PCN # 2025010		Issued Date 11/20/2025	
PCN Title ATL and ATX No Lens Mount Case Revision.			
Document Version 1.0		Customer Contact Sales@thinklucid.com	
PCN TYPE	<input type="checkbox"/> Electrical Specification	<input type="checkbox"/> Regulatory or Compliance	
	<input checked="" type="checkbox"/> Mechanical Specification	<input type="checkbox"/> Part Number Change	
	<input type="checkbox"/> Optical Specification	<input type="checkbox"/> End of Life	
	<input type="checkbox"/> Firmware Specification	<input type="checkbox"/> Other	
Affected Part Number(S)			
PART NUMBER		DESCRIPTION	
ATL314S-CNL		Atlas Camera IMX342 31.4MP Color No Lens Mount	
ATL314S-MNL		Atlas Camera IMX342 31.4MP BW No Lens Mount	
ATX314S-CNL		Atlas 10G Camera IMX342 31.4MP Color No Lens Mount	
ATX314S-MNL		Atlas 10G Camera IMX342 31.4MP BW No Lens Mount	
CPN0250-002		Atlas 10G Camera IMX342 31.4MP BW NLM RCG	
CPN0250-004		Atlas 10G Camera IMX342 31.4MP BW NLM CUST

Reason and Description of the Product Change

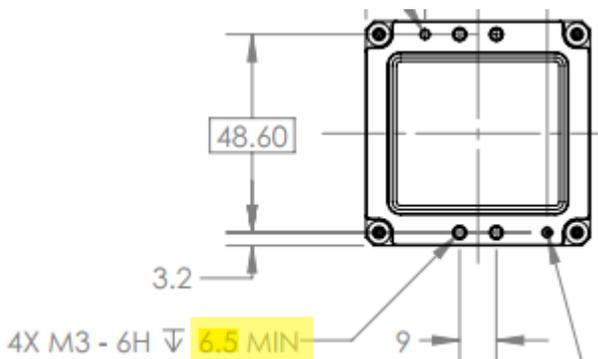
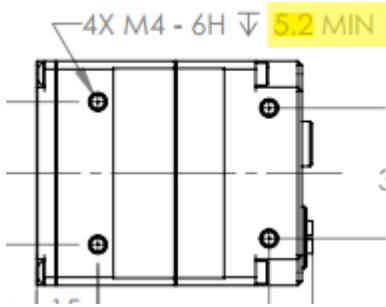
The middle case for the no-lens-mount ATL and ATX models is being updated. The bottom mounting hole depth will be reduced from 6 mm to 5.2 mm, and the front mounting hole depth will be reduced from 6.8 mm to 6.5 mm. Please refer to the diagram below for details on the changes.
